Re: Letter of Correspondence #1  
Site Plan Review  
Shared Maintenance Facility  
185 Windham Center Road, Windham, Maine

**SITE LAYOUT & UTILITY PLAN**

**GRADING, DRAINAGE, AND EROSION CONTROL PLAN**

**C-6**

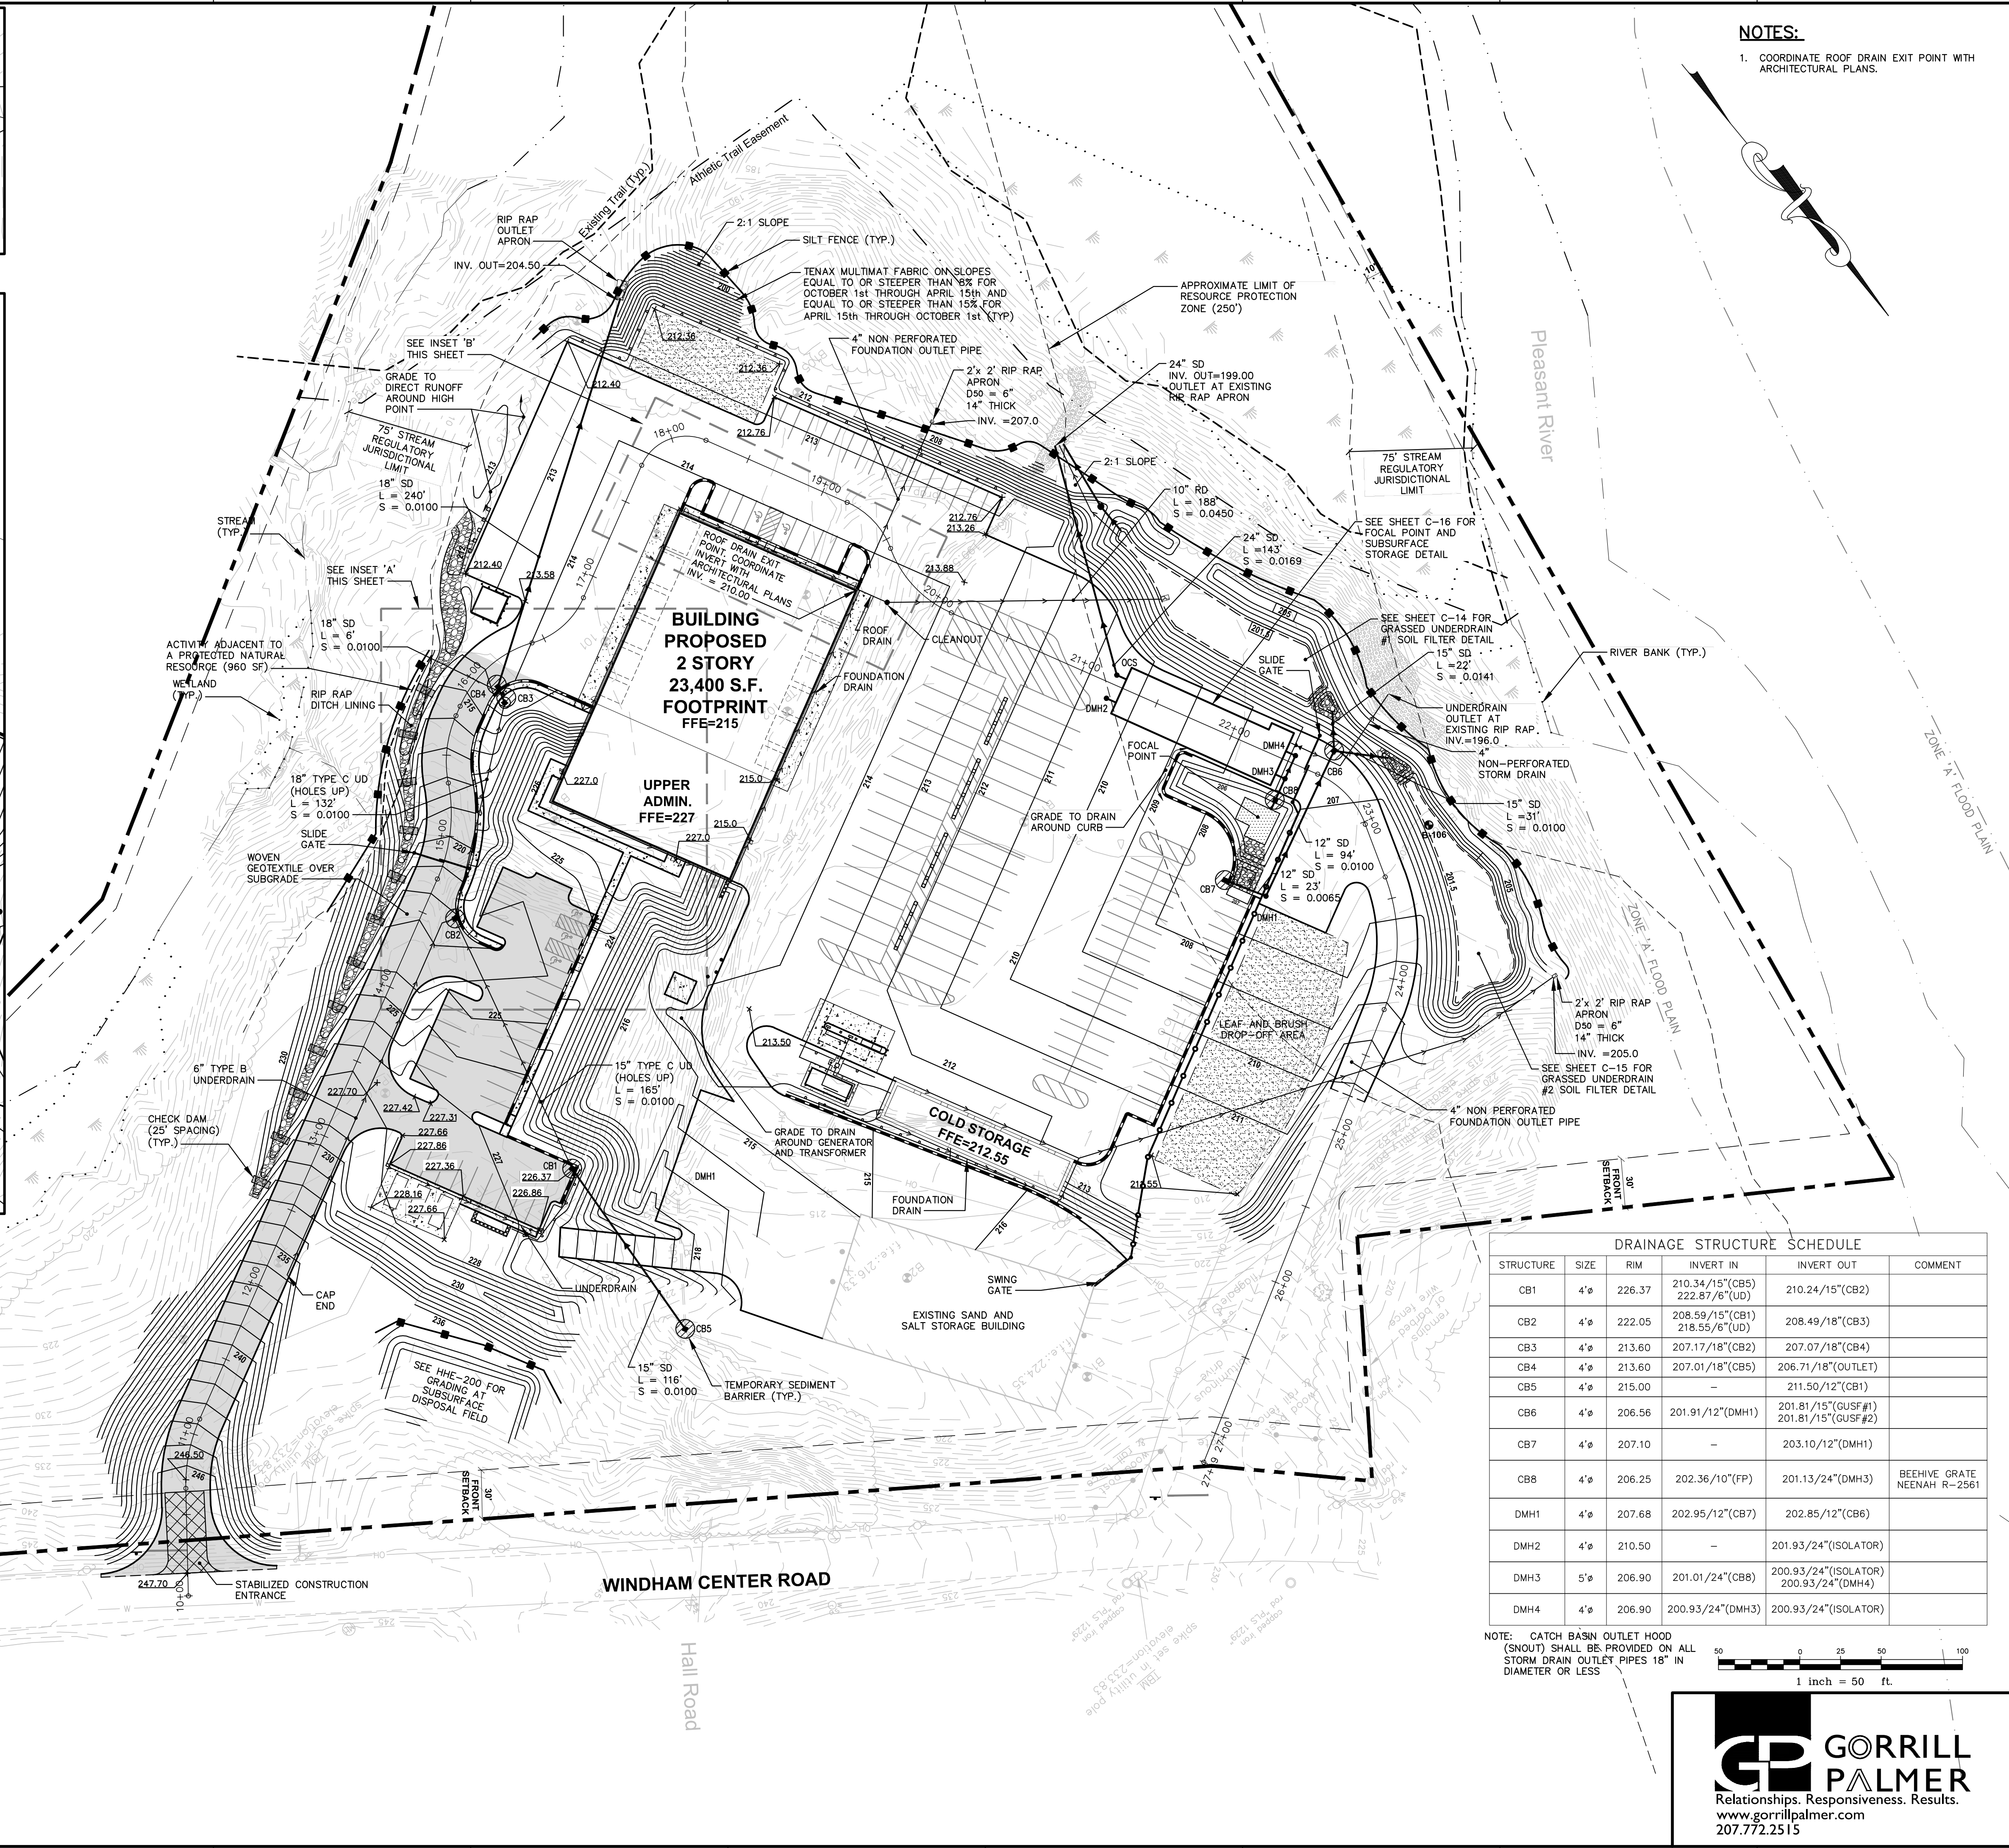
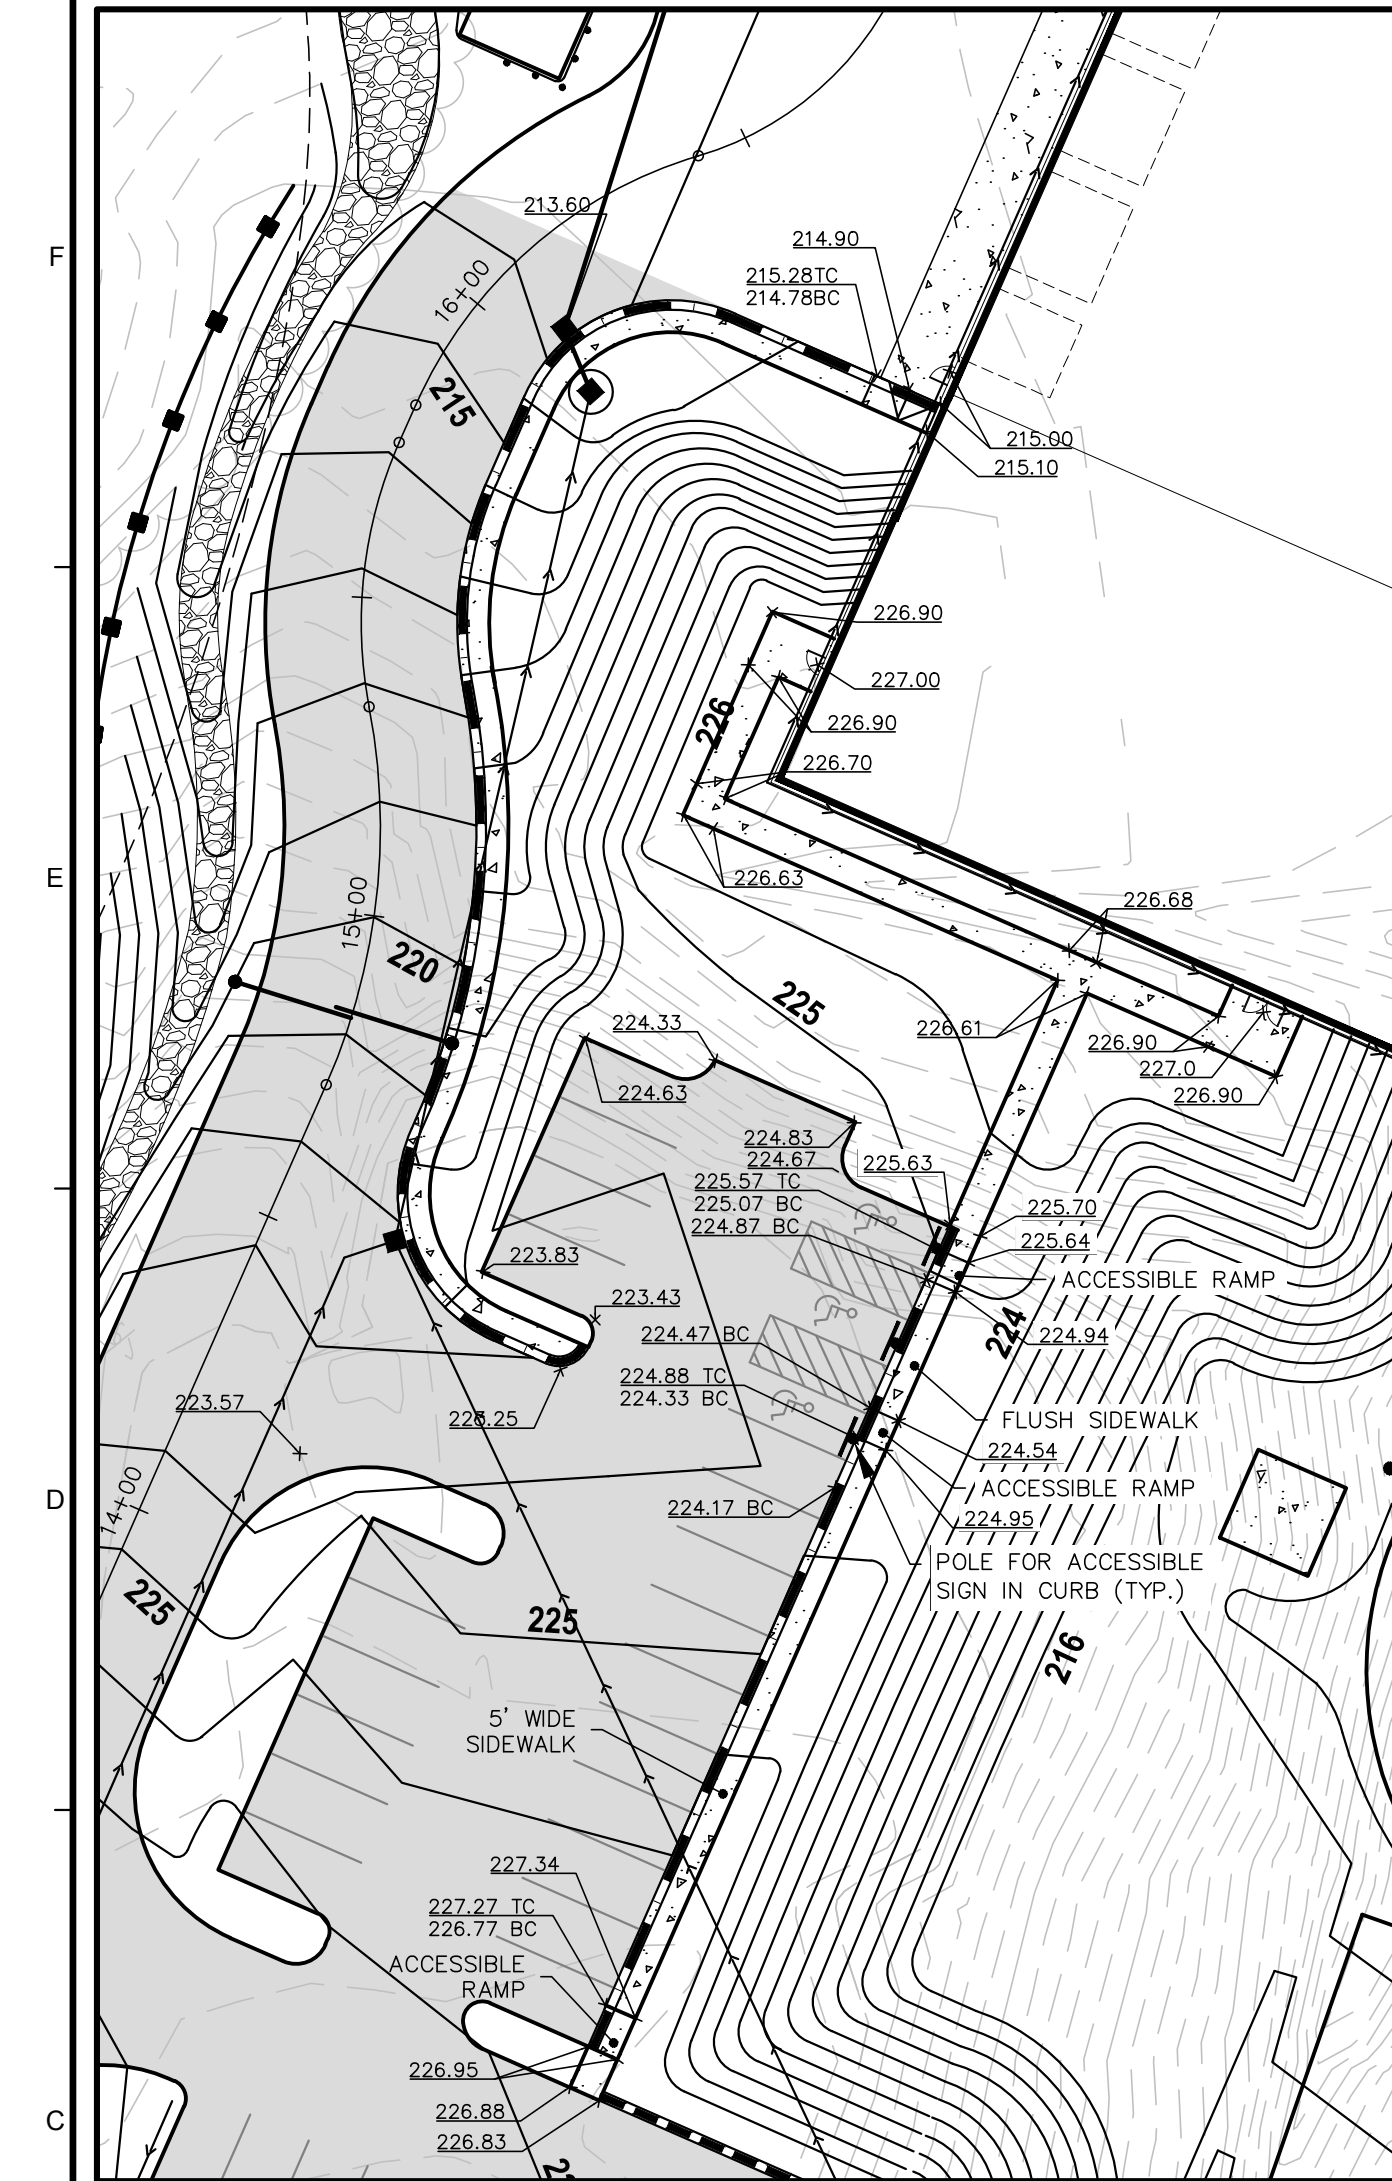
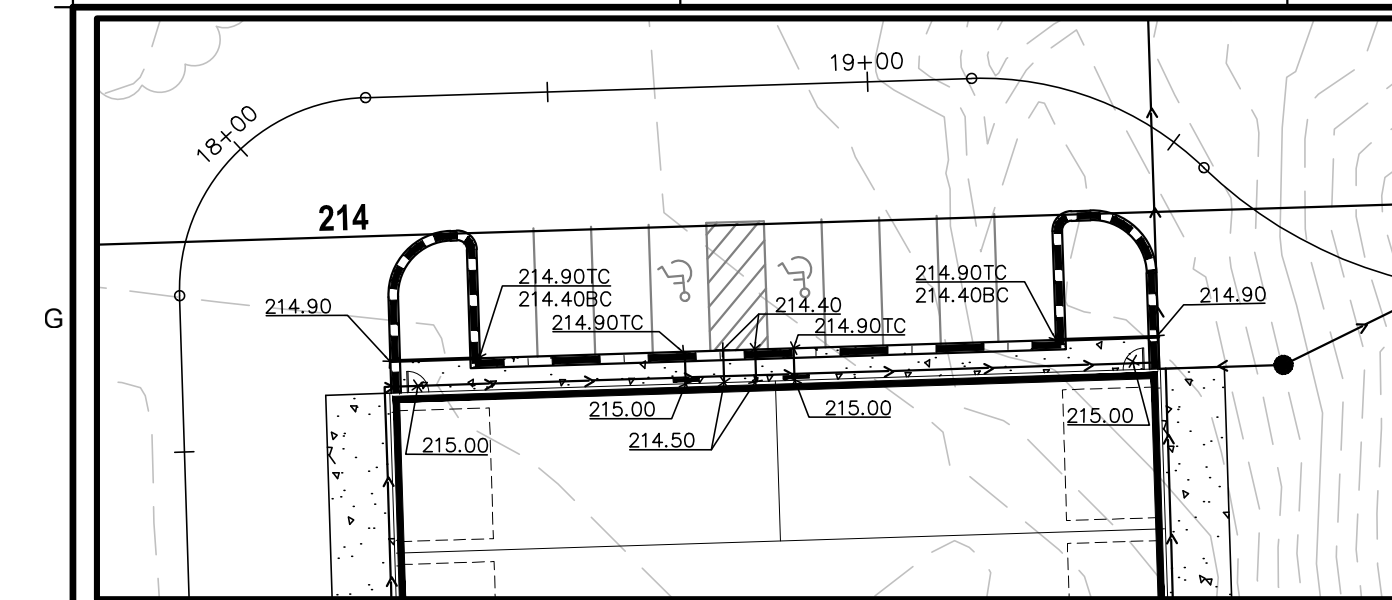
Based upon comments received at the planning board meeting on April 23, Gorrill Palmer has prepared revised plans showing an option for relocation of the fuel tanks, and a discussion of the site impacts within the stream buffer area. The following narrative presents our response.

The Site Layout and Utility Plan, and the Grading, Drainage, and Erosion Control Plan attached to this letter contain an option for the location of the fuel tanks and dispensers. Given the location of the existing Public Works site and the constraints of the site layout, any location on the site is tributary to either the Pleasant River or the unnamed stream (which is also tributary to the river). The location of the fueling station shown on the revised plans is roughly as far from the Pleasant River or the stream as is possible for this site. The proposed location is tributary to the Focal Point filtration system which would provide an opportunity for containing any spills before they reach the river. The Focal Point system is lined with an impermeable liner and contains an outlet control valve on the chamber system underdrain that could be closed in the event of a spill. The additional flow path across the parking lot provided by this option presents an opportunity to intercept a spill with oil absorbent booms which are kept on-site for spill control as part of the site's Spill Prevention Control and Countermeasure Plan. As with the original layout, the fuel system will consist of dual wall tanks that are electronically monitored for leakage, dual wall piping that is electronically monitored for leakage, and collection sumps at fuel tank filling and valve locations. The dispenser pumps are equipped with automatic shut off valves that will shut off fuel flow if a dispenser hose is damaged. The original fuel system location is being reviewed by the MDEP for its siting and for the Spill Prevention Control and Countermeasure Plan for this site. The revised system location would need approval from MDEP (as a Minor Revision) if the revised location was preferred by the Town. It is our position that either location of the fueling station is safe and an improvement over the existing condition.

to be limited to the extent practicable. An application for an NRPA Permit by Rule has been submitted to the MDEP for the proposed 960 sf impact and is currently under review. The existing stream buffer (both 75' and 100') are currently impacted by development, and the proposed project will reduce impacts in both the 75' and 100' buffer. The proposed impervious area within the 75 foot buffer will be reduced by 1,600 sf from current conditions, and an area of 7,350 sf of previously disturbed vegetation will be designated for natural regrowth (not mowed more than 2 times per year). It is impracticable to redesign the project to eliminate grading impacts within the 75' and 100' stream buffer without detrimental impacts to the safe operation of the site.
